FORWARDING LIC NOS DPR-39, 47 & 55 APPL FOR AMEND: TECH SPEC PROPOSED

CHANGE CONCERNING REVISION TO THE CORE PROTECTION SAFETY LIMITS AND
PROTECTIVE SYSTEM MAXIMUM ALLOWABLE SETPOINTS, IN SUPPORT OF OPERATION FOR
FULL RATED PWR DURING CYCLE 4... W/ATT R - BAW-1491, Oconee Unit 2, cycle 4
50-270

PLANT NAME: OCONEE - UNIT 1
OCONEE - UNIT 2
OCONEE - UNIT 3

Also attached is Babcock and Wilcox Report BAW-1491, "Oconee Unit 2, Cycle 4 Reload Report." This report includes a summary of Cycle 4 operating parameters and contains the safety analyses supporting the operation of Oconee 2, Cycle 4 core at rated power in accordance with the Technical Specifications provided.

OCONEE NUCLEAR STATION
Figure 2.1-2B

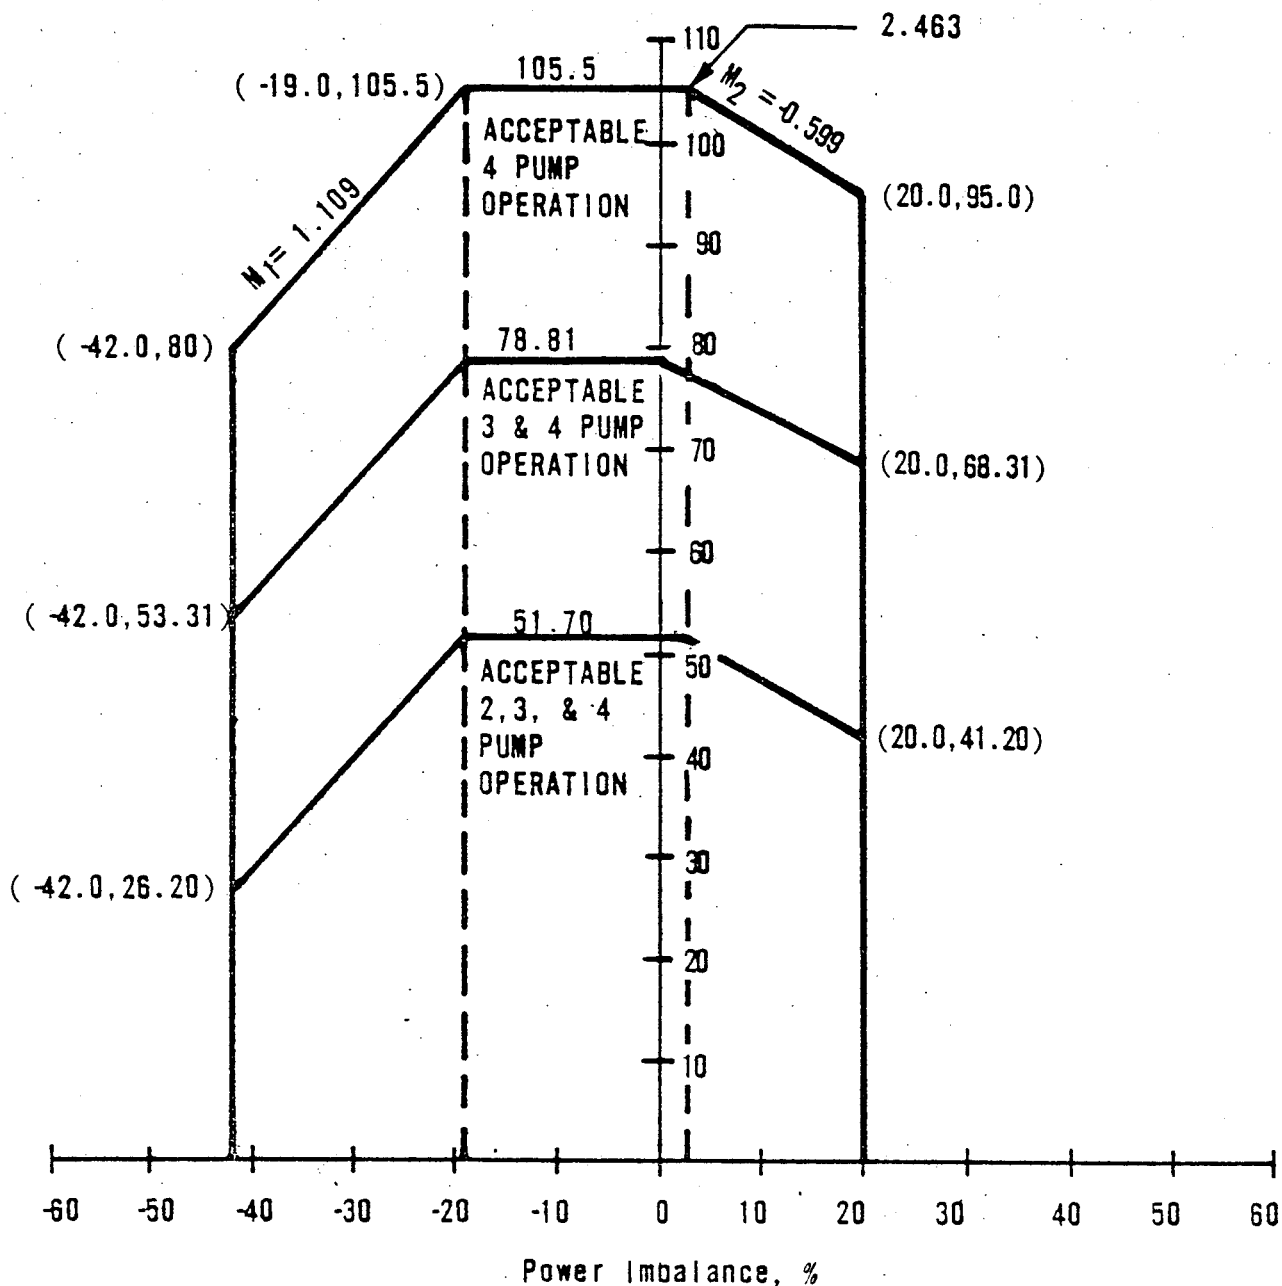
The curves of Figure 2.1-2B are based on the more restrictive of two thermal limits and include the effects of potential fuel densification and fuel rod bowing:

1. The 1.30 DNBR limit produced by the combination of the radial peak, axial peak and position of the axial peak that yields no less than a 1.30 DNBR.
2. The combination of radial and axial peak that causes central fuel melting at the hot spot. The limit is 19.8 kw/ft for Unit 2.

The specified flow rates for Curves 1, 2, and 3 of Figure 2.1-2B correspond to the expected minimum flow rates with four pumps, three pumps, and one pump in each loop, respectively.

Figure 8-1. Core Protection Safety Limits

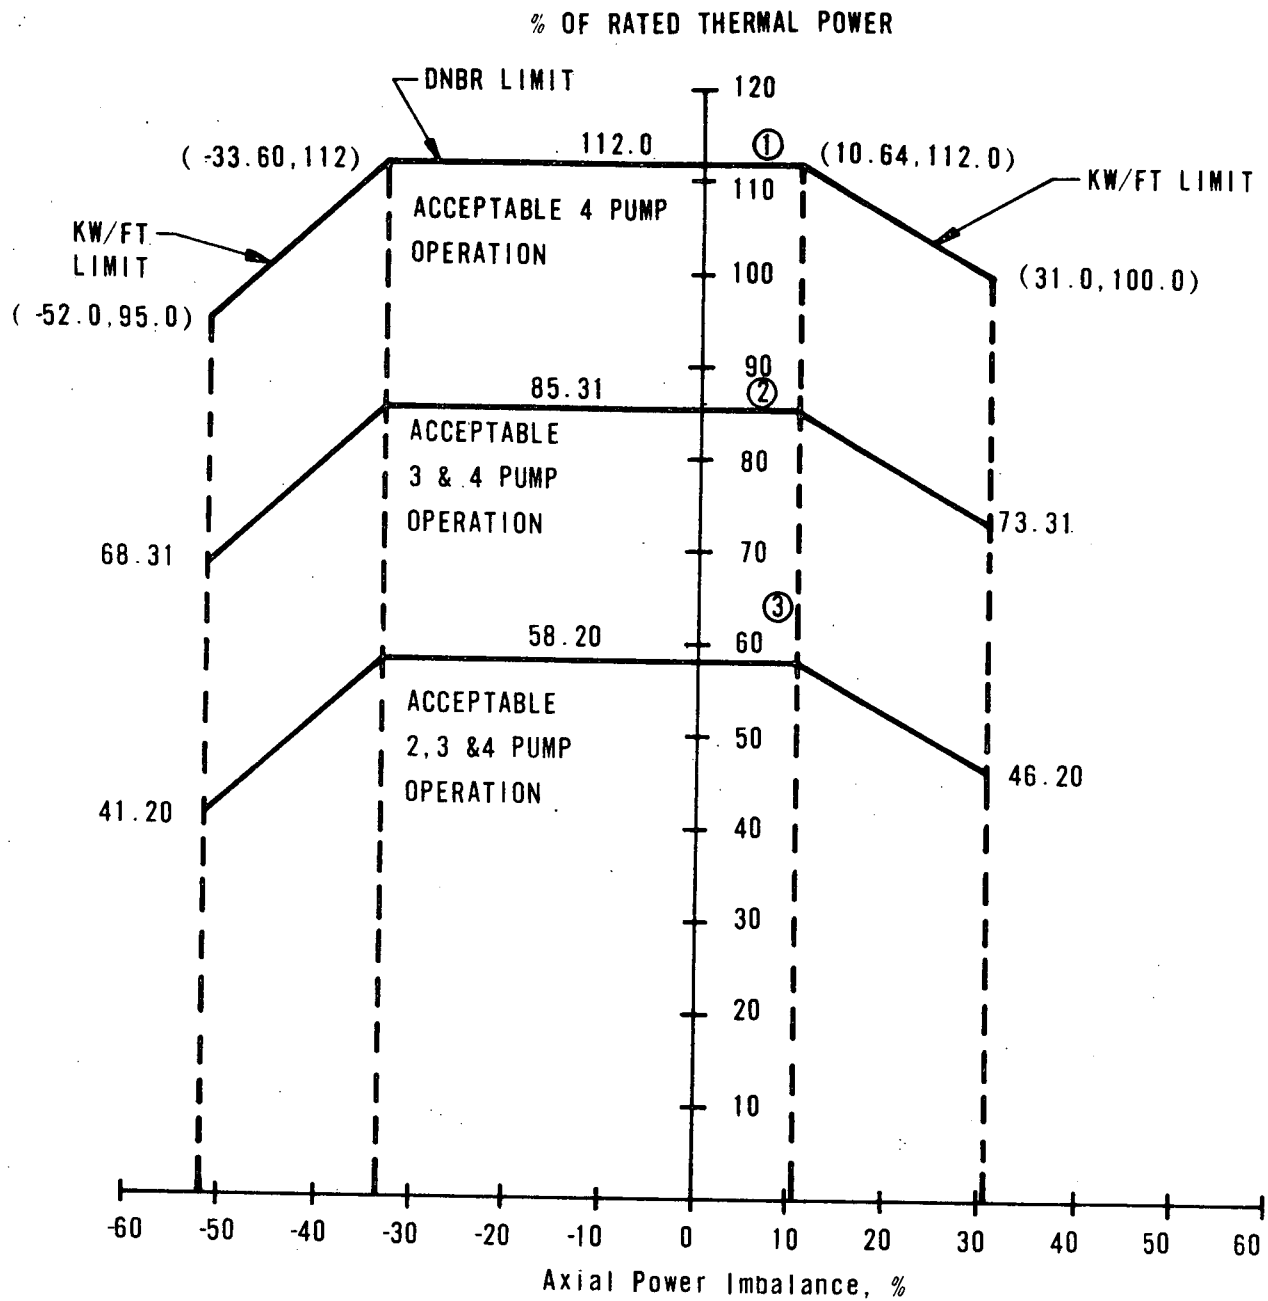
The Technical Specifications have been revised for cycle 4 operation to account for minor changes in power peaking and control rod worths inherent with non-equilibrium cycles. In addition, changes were the result of the following:

1. The Technical Specification limits based on DNBR and LHR criteria include appropriate allowances for projected fuel rod bow penalties, i.e., potential reduction in DNBR and increase in power peaks. A statistical combination of the nuclear uncertainty factor, engineering hot channel factor, and rod bow peaking penalty was used in evaluating LHR criteria, as approved in reference 8.
2. Per reference 9, the power spike penalty due to fuel densification was not used in setting the DNBR- and ECCS-dependent Technical Specification limits.
3. The allowable quadrant tilt limit for cycle 4 is 5.0%. A power peaking penalty (1.075) appropriate for this quadrant tilt limit was used to set imbalance and rod insertion limits.
